KB8113 Firmware V2.2.51_230109 Release Note (2023-01-19)

Device Model	DS-KB8113-IME1
Firmware Version	V2.2.51_230109
iVMS-4200 Version	Latest version
Hik-Connect APP	Latest version

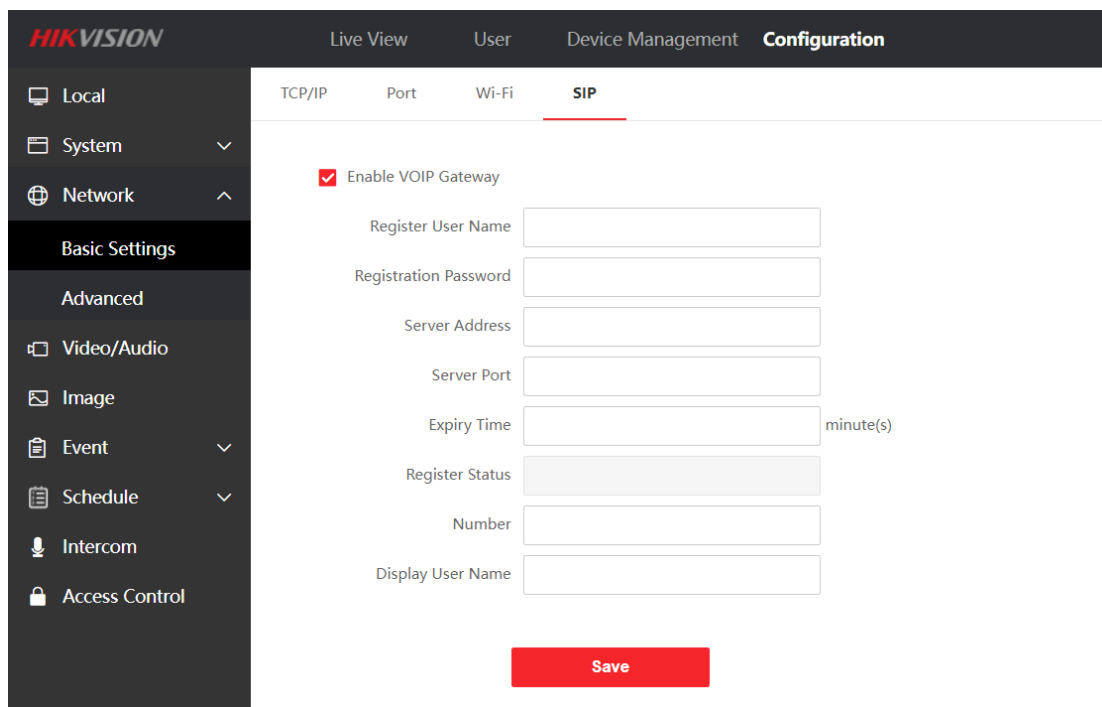
1. Optimize exit button detection logic and increase button detection sensitivity
2. Correction of the audio file in standard Portuguese

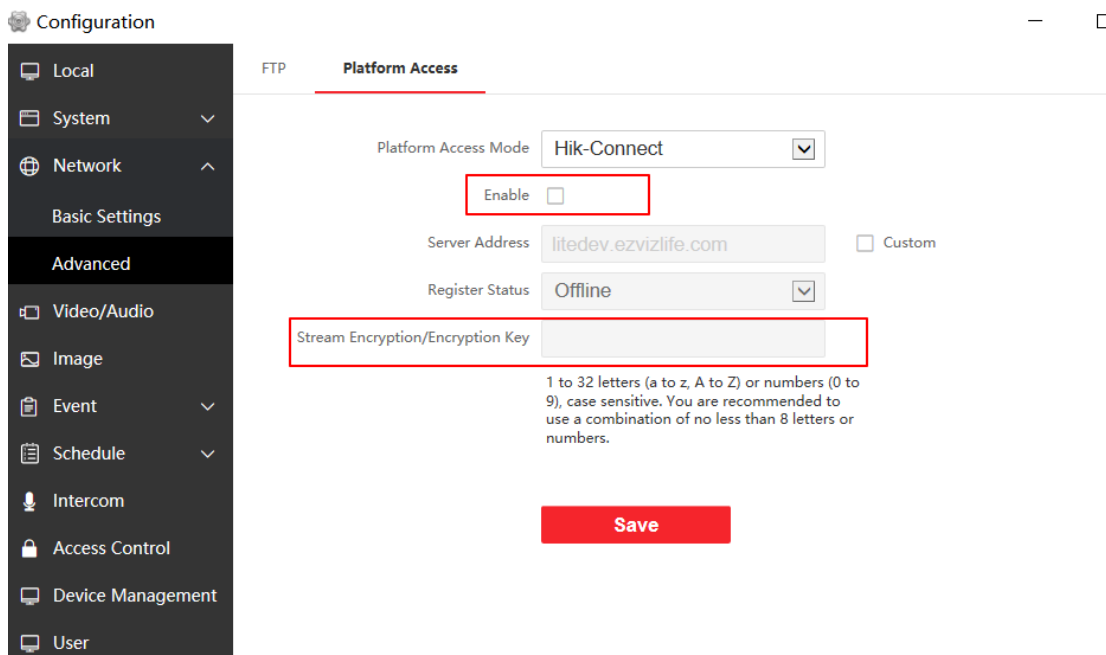
1、 HiK-Connect is disabled and Verification code is empty by default.

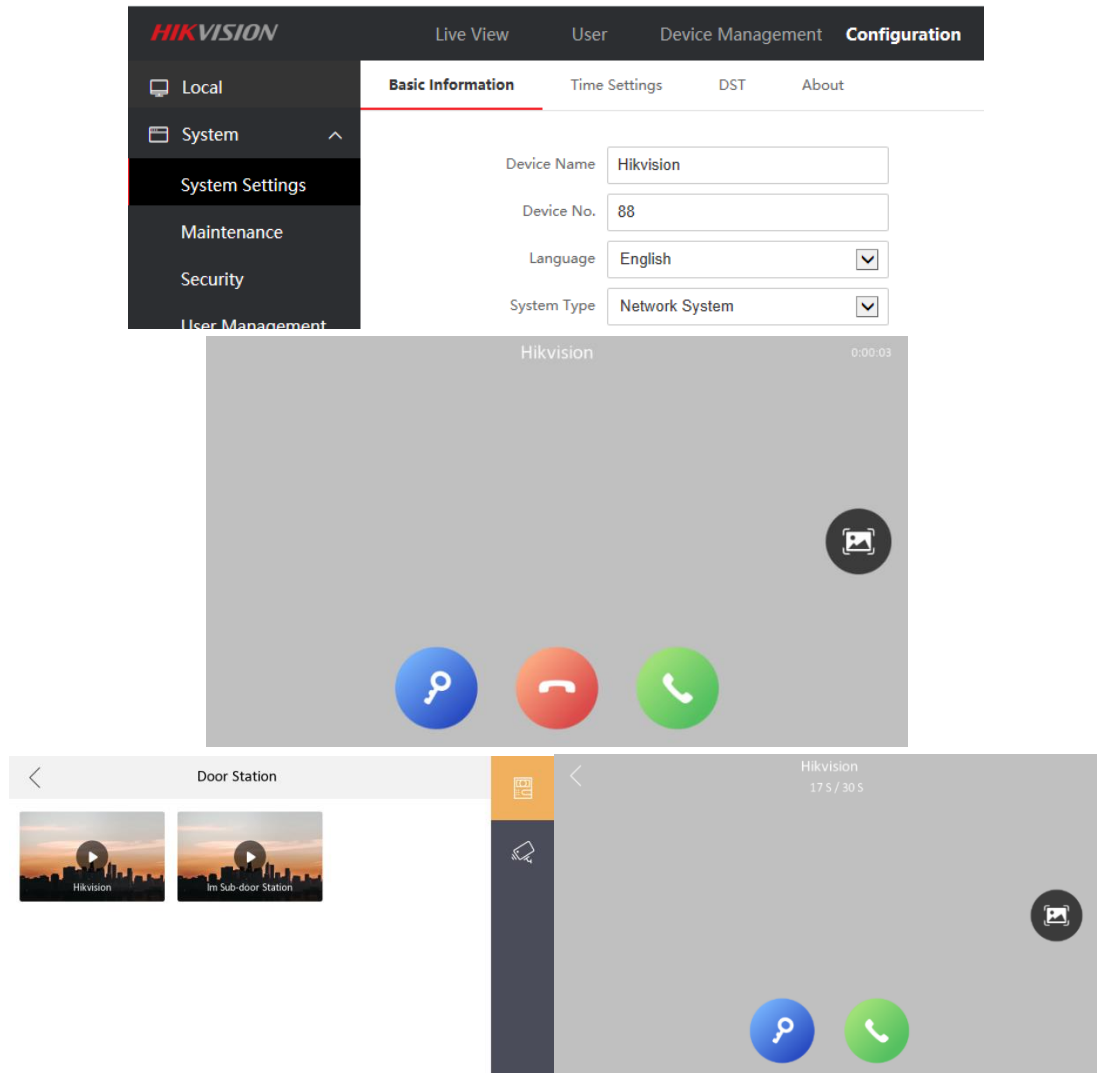
1. The changed name of the door station will be displayed on the call interface or preview interface of the indoor station

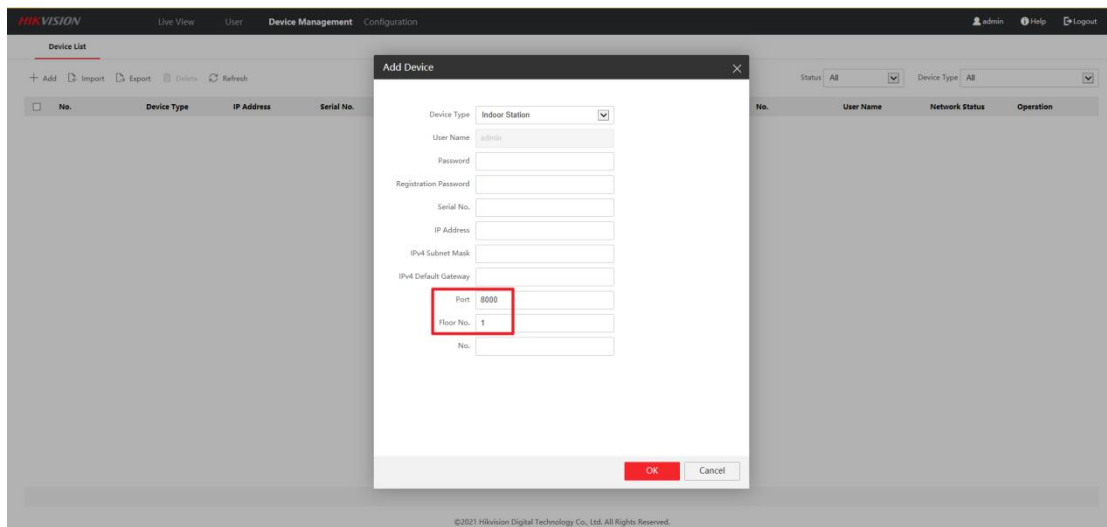
2. Add indoor station or sub-door station to iVMS-4200 or WEB to add default value

3. If the Registration Password in the door station WEB interface has been configured, it will be displayed in cipher text

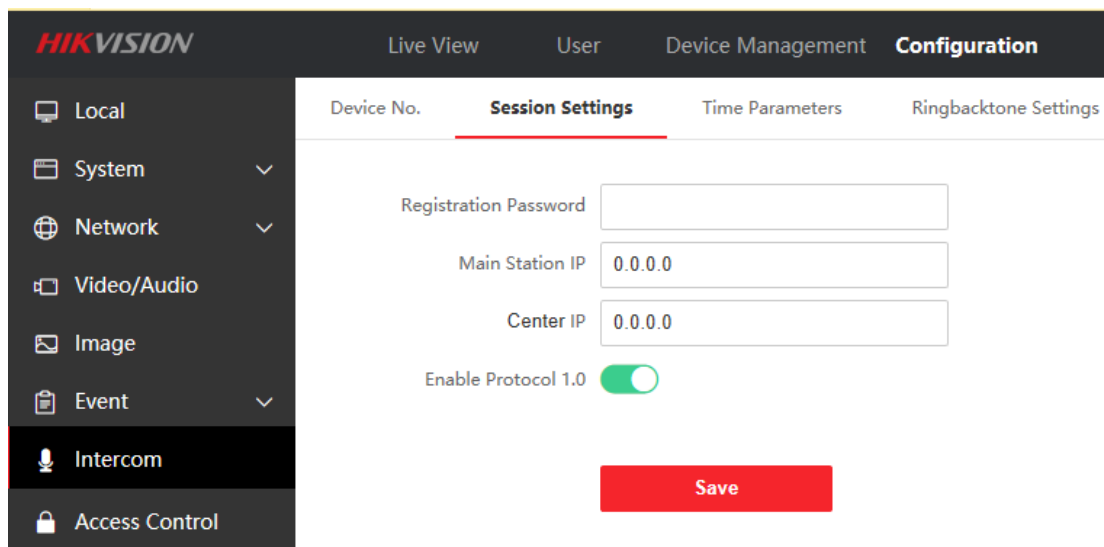
4. Video Intercom Server IP (Private SIP server IP) naming changed to Center IP

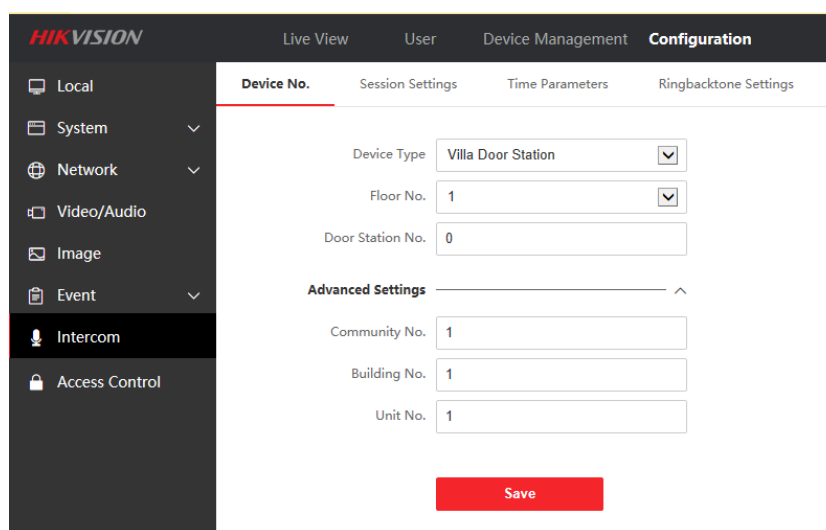
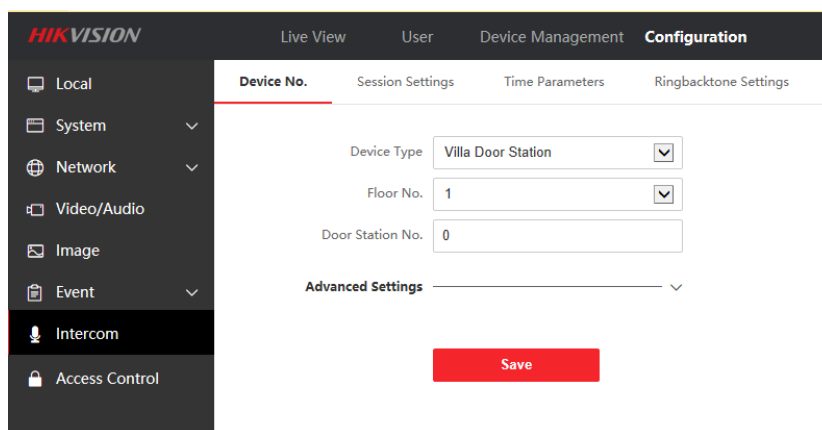
5. The WEB or iVMS-4200 interface community number, building number, and unit number of the door station will be stored in the advanced settings column instead of being displayed directly

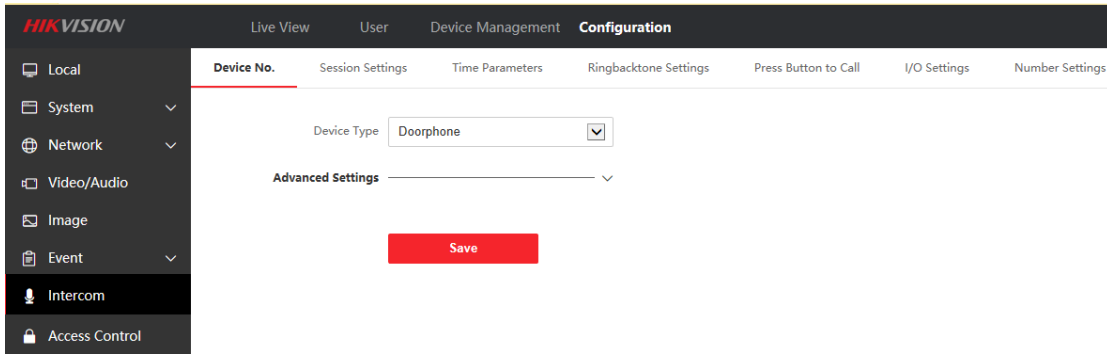
6. Support doorphone mode, when this function is enabled, the door station will no longer actively synchronize the information of the indoor station

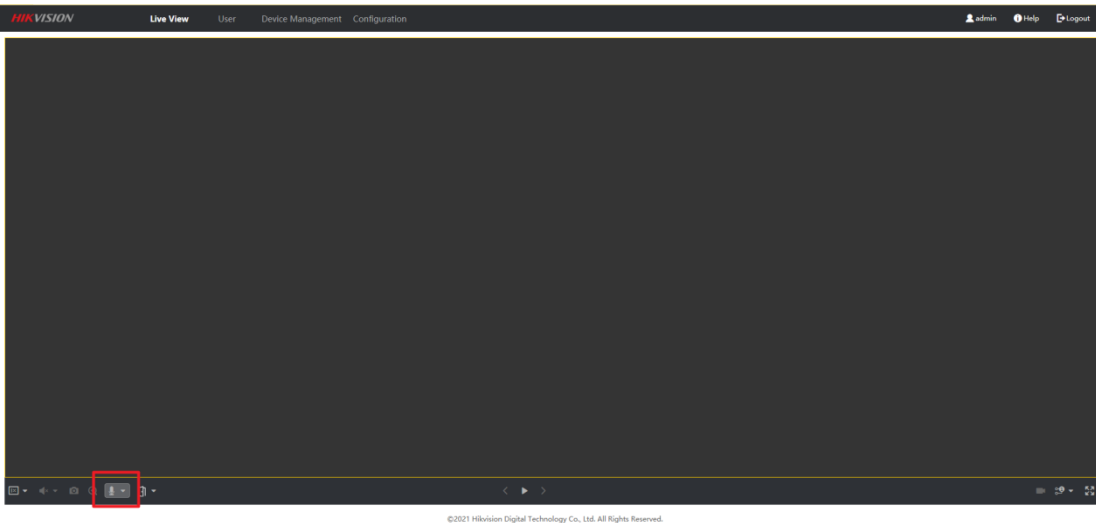
1. Now the doorbell KB8113 has an intercom button on the WEB interface, which can actively send intercom
